Subject: Transmittal of Revision 3 to Service Bulletin No. V2500-ENG-72-0127

INFORMATION - ENGINE - PROVIDE A NEW DEOILER CARBON SEAL
(FOR CONTROLLED SERVICE USE)

V2500-A1 Engines

V2500-ENG-72-0127

Remove and install the seal assembly
Figure 1

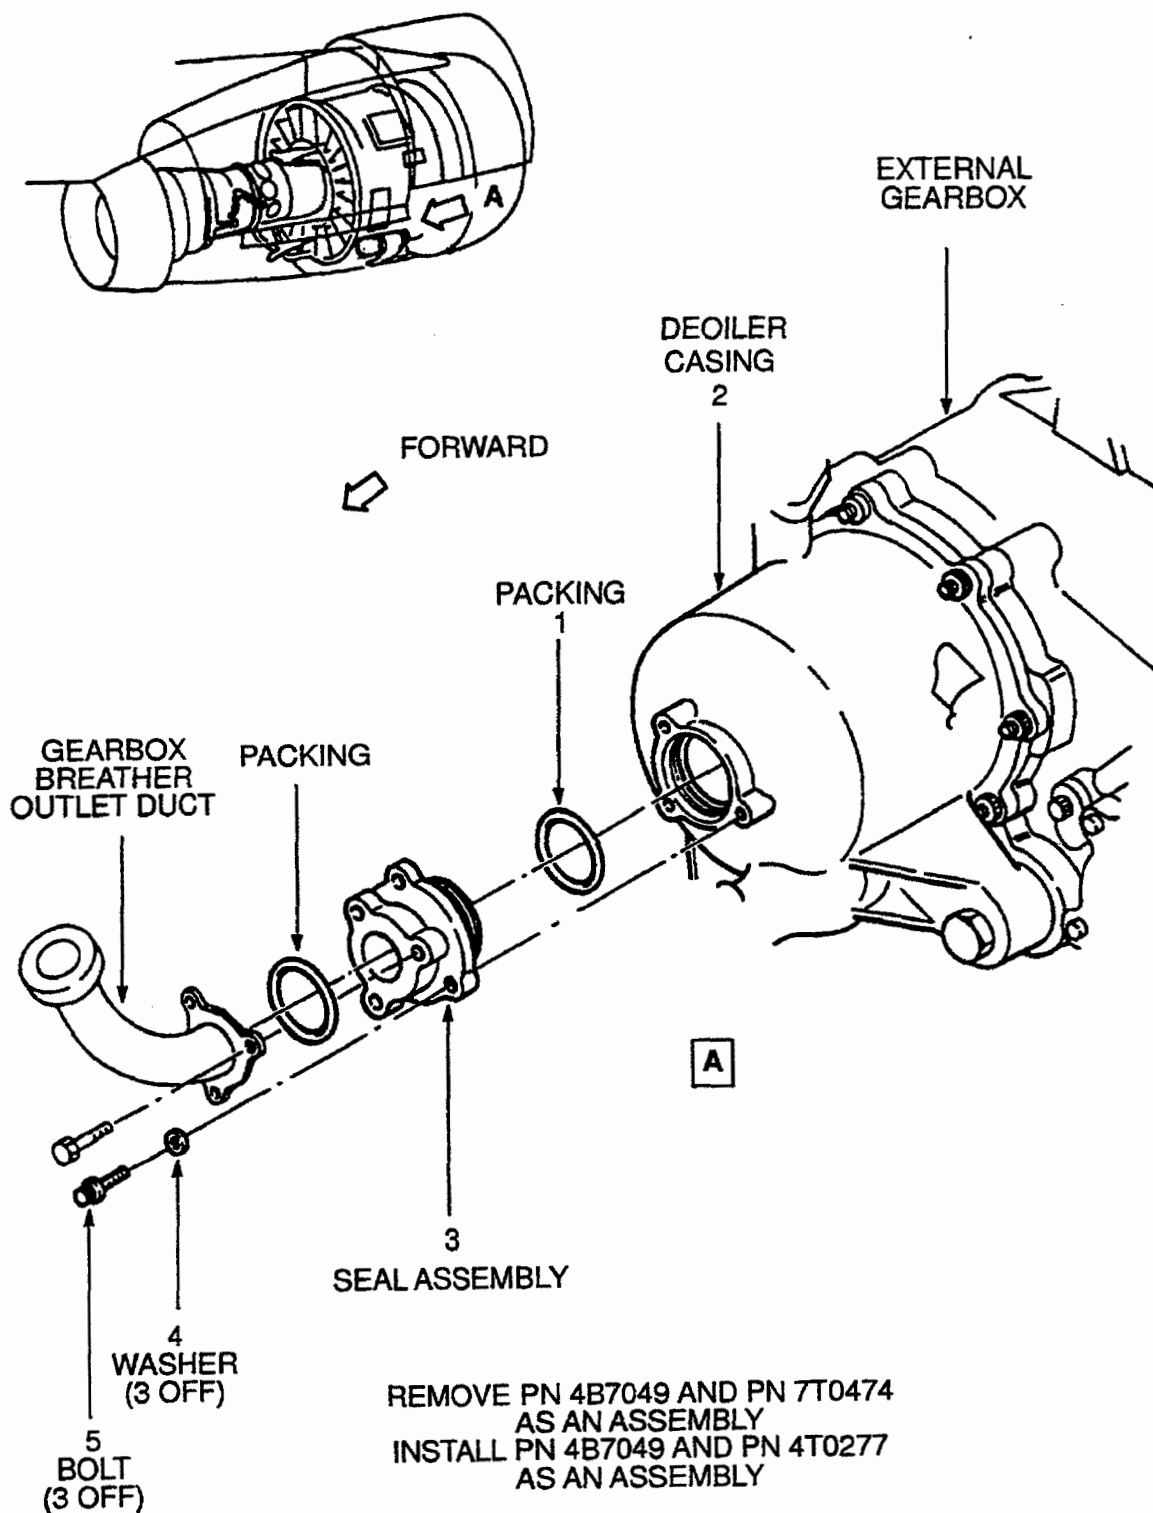
- (6) Remove the gearbox breather outlet duct by the approved procedure in Reference (2) Chapter/Section 72-61-49 Removal/Installation.
- (7) Remove the seal assembly (Ref Fig 1)

- (a) Remove the three bolts (5) and the washers (4) which attach the seal assembly (3) to the deoiler casing (2).
 - (b) Install the puller, IAE 1F10067 on to the seal assembly (3)

- (c) Use the puller, IAE 1F10067, to remove the seal assembly (3)
 - (d) Remove and discard the packing (1).
 - (e) Remove the puller IAE 1F10067 from the seal assembly (3)

- (f) Discard the seal assembly.

(10) Install the seal assembly (Ref Fig 1)

R NOTE: The seal assembly (3) consist of the P/N 4B7049 carbon seal
R housing and the new P/N 4T0277 carbon seal. The housing and the
R carbon seal are preassembled.

R (b) Install a new P/N AS3209-143 packing (1) in to the groove of the
new seal assembly (3). (Ref TASK 70-23-13- 911-010).

(c) Align the holes on the seal assembly (3) with the holes on the deoiler casing (2). Use the pusher, IAE1F10072, to fully install the seal assembly (1).

(d) Install the three washers (4) and bolts (5) which attach the seal assembly (3) to the deoiler casing (2).

(e) Torque the bolts (5) to between 85 and 95 lbfin (0,96 and 1,07 mdaN). (Ref TASK 70-23-13- 911-010).

Remove and install the mating ring
Figure 2

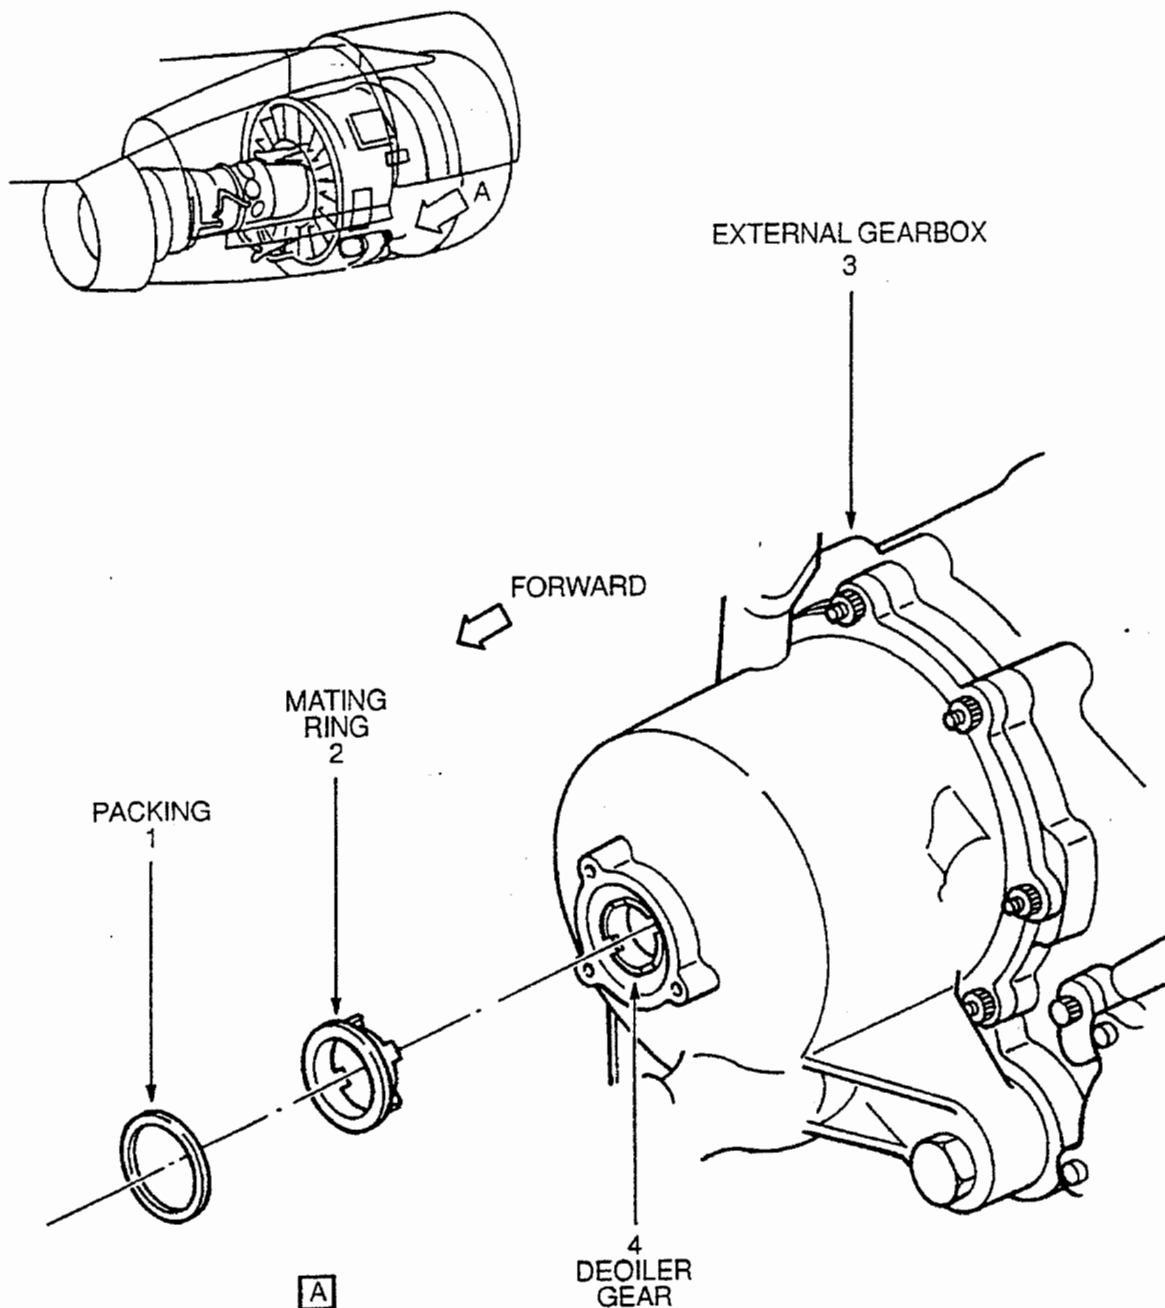
R NOTE 1: P/N 7T0302 mating ring have to be replaced on 5 engines only.
R Remaining five mating rings must be inspected for coking
R evidence and other damage. If there is coking or other damage
R the mating ring must be replaced or removed.

R NOTE 2: It is recommended to remove the mating ring for lapping
R before reuse.

- (8) Remove the mating ring. (Ref Fig 2)
 - (a) Install the puller, IAE 1F10069 on the mating ring (2)

(b) Use the puller, IAE 1F10069 to remove the mating ring (2).

(c) Remove and discard the packing (1).

R (d) Lap the sealing face of the mating ring. Use lapping plate and
R CoMat 05-116 lapping compound. For post repair inspection refer to
R Figure 4. Clean the part using CoMat 01-177 petroleum.

(9) Install the mating ring on deoiler gear. (Ref Fig 2)

R (a) Install a new P/N AS3209-135 packing (1) in to the internal groove
R of P/N 7T0302 mating ring (2). Ref TASK 70-23-13-911-010).

R (d) Align the lugs on the smaller diameter of the mating ring (2) with the slots on the nut.

Data record sheet
Figure 3

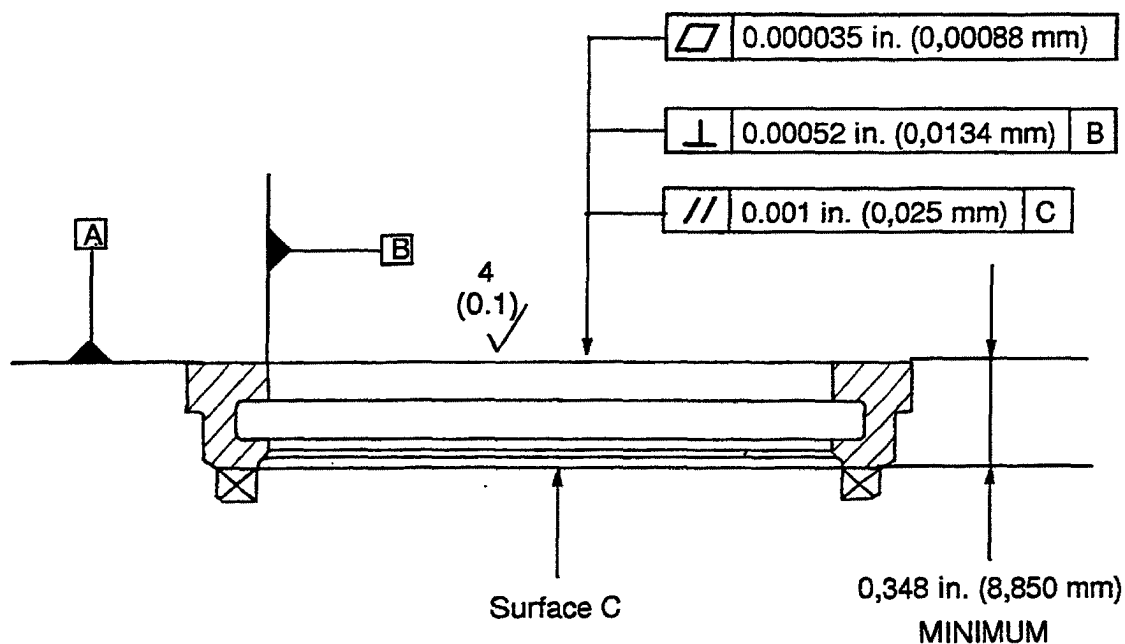
- R (11) Install the gearbox breather outlet duct by the approved procedure in
R Reference (2), Chapter/Section 72-61-49, Removal/Installation. Use
packing AS3209-226 or AS43013-226.
- (12) Close the Fan Cowls by the approved procedure in Reference (2), Chap-
ter/Section 71-13-00, Maintenance Practices.
- (13) Remove the warning notices.
- R (14) Do an oil leak check (Ref TASK 71-00-00-700-012)
- R (15) Provide a data record sheet for the affected engines to IAE on a
R monthly basis during Controlled Service Use (Ref, Fig. 3)
- R (16) Report incorporation of Service Bulletin
